URGENT Field Safety Notification

Spectral CT

Reflective Laser Line May Lead to Misdiagnosis and Subsequent Incorrect Treatment

March 27, 2024

Figure 2. Image showing the single laser line.

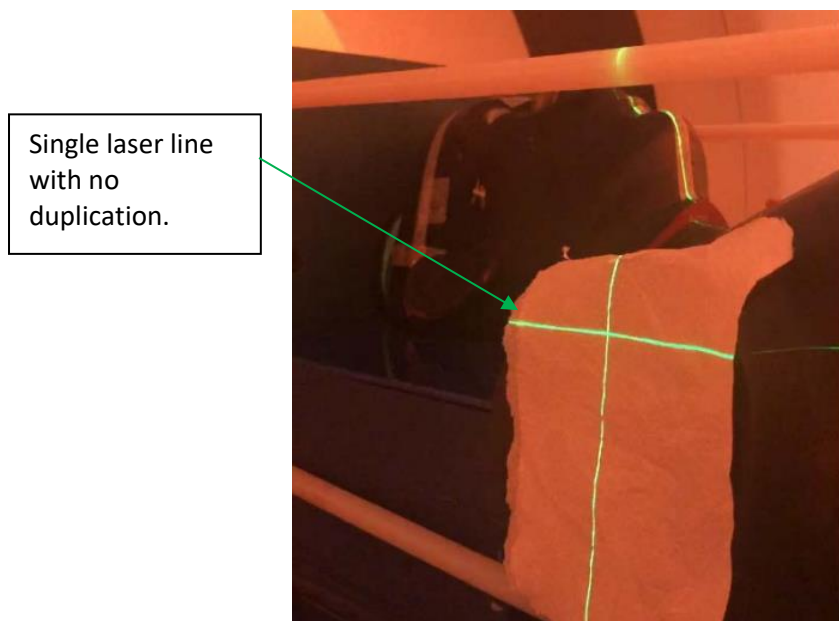
Philips has identified that there is a potential hardware issue with Spectral CT systems that have the NCTE447 Oncology Essentials Package, which allows for a 3rd party oncology marking laser to be installed and used. Systems with an installed laser have the potential for the laser line to be reflected off the gantry cover surface. This reflection can modify the laser line projection to have irregularities in the line, causing the laser line to appear thicker or duplicated (Figure 1).

Representation of the reflected laser line duplicated onto the patient surface. The green arrow points to the laser line, and the red arrow is a demonstration of the laser line that is reflected off the gantry cover, causing the appearance of duplication or thickness of the laser line.

Figure 2 below shows the normal state single laser line, without duplication.

Philips will contact you to schedule a time for a Philips Field Service Engineer (FSE) to visit your site and install the hardware update to resolve the issue (reference FCO72800818).
